# Groundwater Transfer Review Summary Form

Transfer/PA # T- 13852

Application: T-13852

Applicant Name: G and F Sester Family LLC

### Theis Drawdown Analysis – Authorized From-POA MULT 3476 to Permit G-15183 POA Location

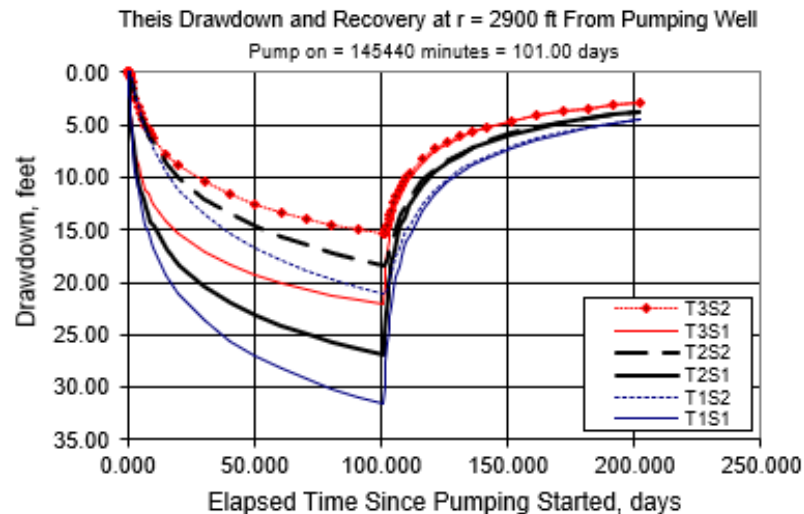
To evaluate the potential additional interference with the nearby POA for permit G-15183, a Theis (1935) drawdown analysis was completed. Aquifer parameters used for the analysis were derived from regional data and studies (Pumping Test Reports; McFarland and Morgan, 1996; Swanson et al., 1993).

To provide a conservative analysis, it was assumed that authorized From-POA MULT 3476 would be pumped non-stop at the maximum authorized rate for the 34.5-acre primary irrigation portion (0.43 cfs, ~193 gpm) up to the associated duty, which would be reached within approximately 101 days of pumping (note: additional pumping rate allocations authorized for MULT 3476 (Well 1) by its other water rights were not included for this analysis. Not stacking those additional authorized rates results in this comparative interference analysis being even more conservative; this is because with less interference drawdown imposed by MULT 3476 on nearby wells, the resulting *net difference* when compared to the proposed change (increased pumping rate at MULT 55482) is effectively greater).

Results of the Theis comparative analysis indicate that interference with the permit G-15183 POA could range from about 36 to 66 feet based on these conservative pumping scenarios. Using pumping water level estimates for the affected G-15183 POA (based on a specific capacity value derived from pumping test data from MULT 3476), and assuming the G-15183 POA well would be completed to 550 ft bls (fully penetrating the Deep Troutdale aquifer), it was determined that sufficient available drawdown would be available in the G-15183 POA well; this is despite the relatively-large amount of additional drawdown (~36-66 feet) predicted under these conservative scenarios. Therefore, it is not likely that the proposed use will result in the G-15183 POA or another similar groundwater right from receiving the water to which it is legally entitled.

## Theis Drawdown Analysis – Proposed To-POA MULT 55482 to Permit G-15183 POA Location

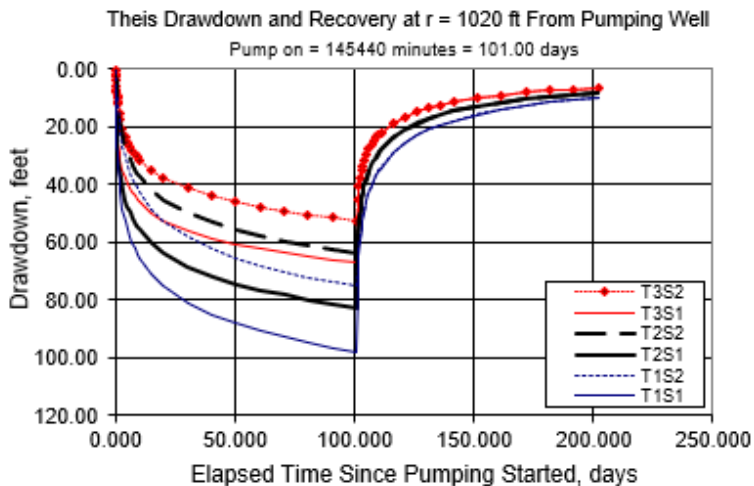
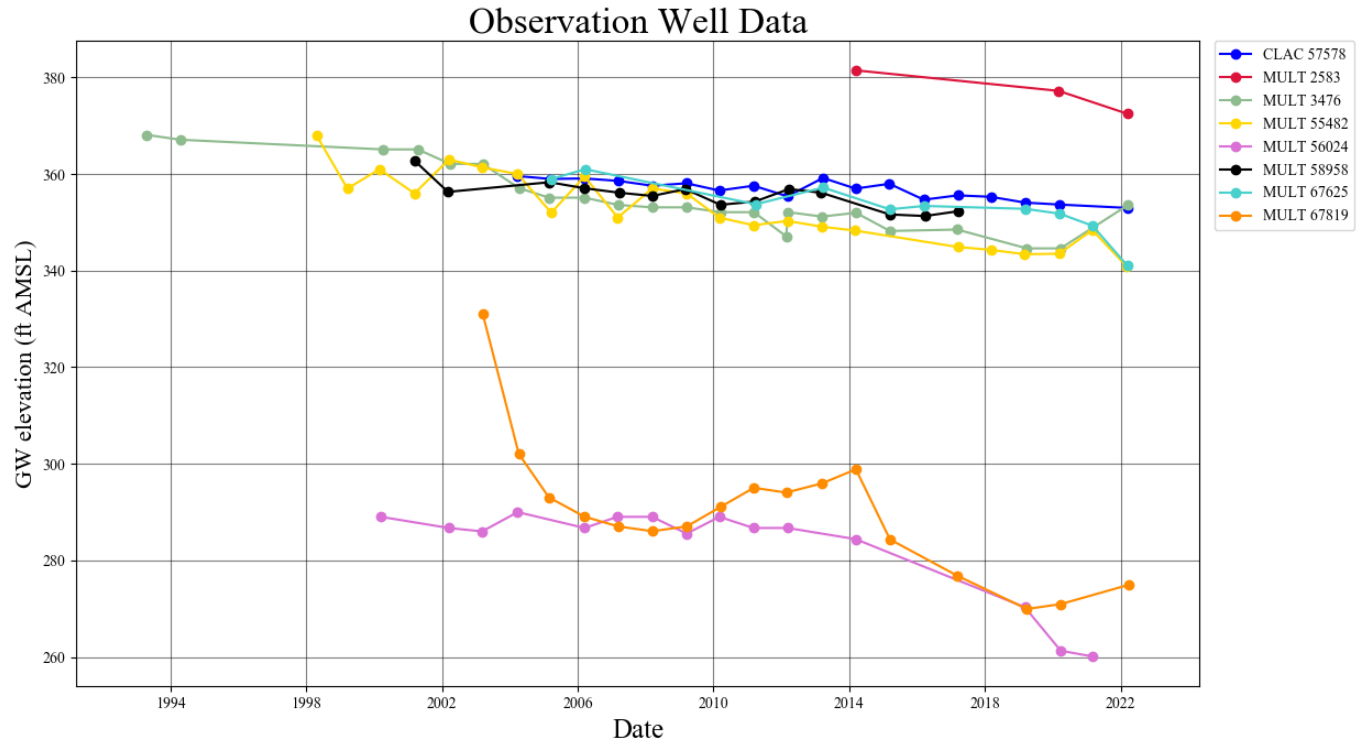
Pumping at the proposed To-POA MULT 55482 location was simulated at 0.93 cfs (~417 gpm), which is the combined total for the rate currently authorized for it by certificate 89728 (0.5 cfs), plus the associated maximum rate authorized by permit G-15758 (0.43 cfs).
